STAFF REPORT: 10/11/2023 REGULAR MEETING
APPLICATION NUMBER: HDC 2023-00048
ADDRESS: 14551 WARWICK
HISTORIC DISTRICT: ROSEDALE PARK
APPLICANT/ PROPERTY OWNER: STEVEN MITCHELL
DATE OF PROVISIONALLY COMPLETE APPLICATION: 9/18/23
DATE OF STAFF SITE VISIT: 6/22/23, 9/21/23

SCOPE: ERECT GARAGE ADDITION

Figure 1, by Applicant: showing proposed front and side elevations of the proposed garage addition. Note that existing garage is the smaller of the two sides, and hatching is not identifying materials correctly for the roof and siding.

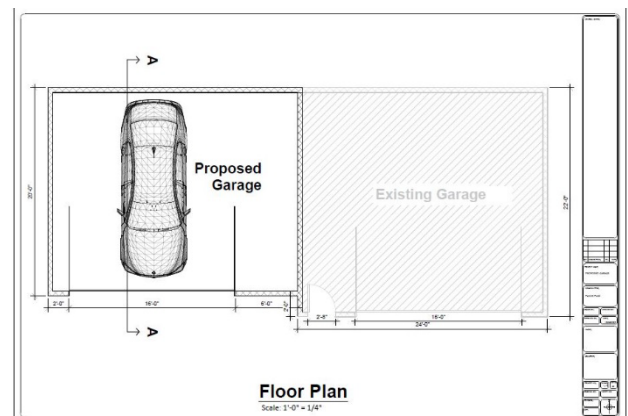
- Staff noticed that the elevation drawings of the application show concrete block hatching, not only for the proposed addition, but also for the original brick garage. The applicant confirmed that the original garage’s brick materials will remain unchanged. (See figure 1.)

- Although staff received product information for the proposed garage door, staff did not receive specific product information regarding the proposed asphalt shingles for the roof, just a screen shot of an image. Although the proposal states that the shingles shall match the existing shingles, the hatching of the drawing shows that they do not match. No product information is cited on the current drawings. (See figure 1.)

- Staff noticed that the proposed drawings have no architect or contractor listed.
- As shown in the Elements of Design above, “*Additions shall be related to the existing structure*”. Staff offers the opinion that the current proposed roof height and pitch (according to the drawings) does not relate to the existing garage, nor is it lower than the existing garage, diminishing and conflicting with these historic features of the existing garage. (See figure 1.)

- The garage addition's roof slope and height conflict with and towers over the existing garage. This not only diminishes the relationship between the existing and proposed features, but also the relationship of the existing garage with the house and property. Therefore, this proposal does not conform with the district's Elements of Design nor does it retain the historic character of the property and spatial relationships that characterize the property (Standards 2 & 9).

- concrete block with an exterior of brick to match the existing garage as close as possible, supplied by Antique Brick, Inc.
- The roof pitch would be changed to match the existing garage pitch.

- The roof height would be lowered to a height that is “a few inches” above the existing garage to “provide proper flashing”.
- The applicant provided sample images of the above to demonstrate his proposed revisions.

Figure 2, by Applicant: showing proposed floor plan for the garage addition. Note that existing garage wall appears to remain in place, but the existing window opening is not shown.

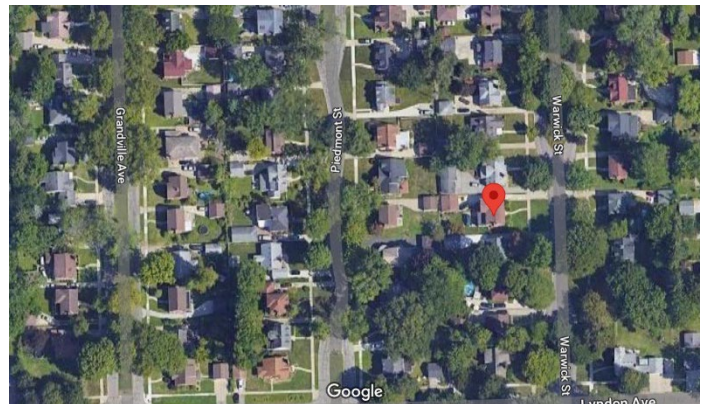
- Staff noticed that the existing garage’s south facing wall and window appear to be untouched by the proposal’s drawings. Staff requested confirmation that this is true but did not receive a response at the time of this report.
